**MANDATORY SERVICE BULLETIN Z 242L/20a**

1. MODELS AFFECTED: ZLIN Z 242L aircraft S/N 0657 and up if they are provided with Maintenance Manual Vol.I. and Vol.II. with Doc.No. 003.022 and 003.032.

2. SUBJECT: Change of airworthiness limitation.
3. CORRECTION:
  - a) Change of Section 5.4. "Possible Failures of Main Wing Spar and Their Remedies (Structural Inspection)" and change of Chapter 9. "Airworthiness limitation" in Maintenance Manual of Z 242L Aircraft, Vol. I.

Fig.: Replacement of 5 DuK 4x15P rivet (ČSN 02 2302.5) with M 5x20 ONL 3120.24 fitted bolt

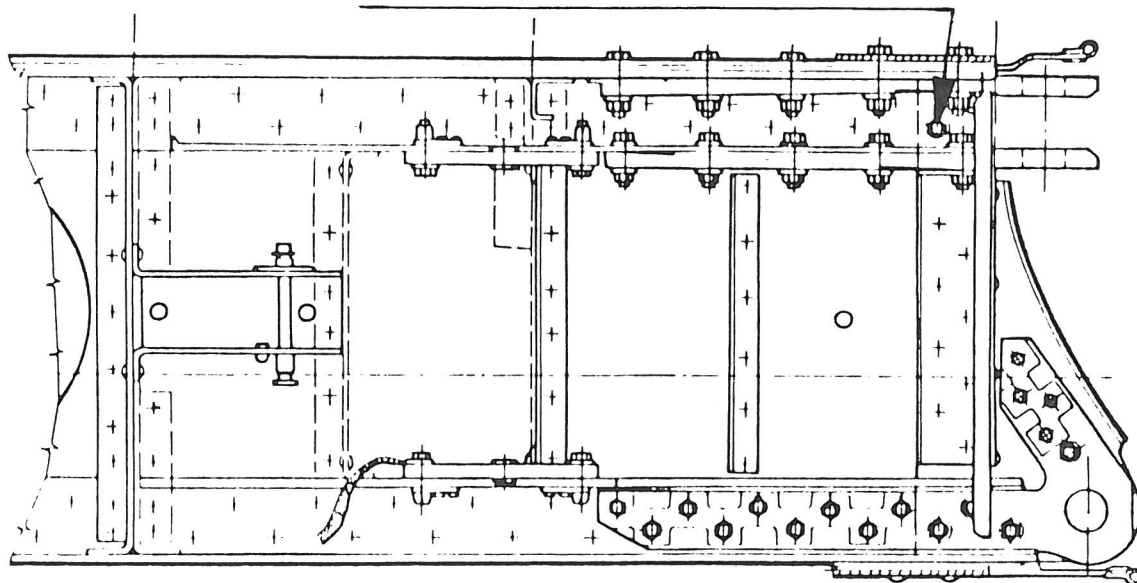
- b) Replacement of rivet with fitted bolt in the upper flange of the main spar root part of L.H. as well as R.H. wing.
  - c) Replacement off fitted bolts at upper wing attachment fittings after every 1500 flight hours and completion of Maintenance Manual, Vol.II, connected with this.

Rivet replaced with fitted bolt

5. Using hand electrical drilling machine with angular extension piece for spindle deflection by 90° drill out the rivet supporting head (see Fig.) and a part of its shank (to the depth of about 1/3 of the overall material thickness gripped) with a drill  $\phi$  4.1 and overall length of 65 mm). Drive out the remaining part of the rivet with a suitable driving-out mandrel.
6. Re-drill the holes remained after the removed light-alloy rivets with hand el. drilling machine having an angular extension piece on it. Use a drill  $\phi$  4.8 and with overall length of 65 mm. When drilling the drilling machine must be in perpendicular position to flange area!!!

7. Ream the re-drilled holes with hand reamer  $\phi$  5H7 and ratchet wrench.
8. Remove chips that result from drilling and reaming.
9. Check the reamed holes with plug gauge.
10. Mount bolt M 5x20 ONL 3120.24 with washers 5.3 CSN 02 1702.14 placed under the bolt head and under the nut M5 ONL 3247, into the cleaned, reamed hole.
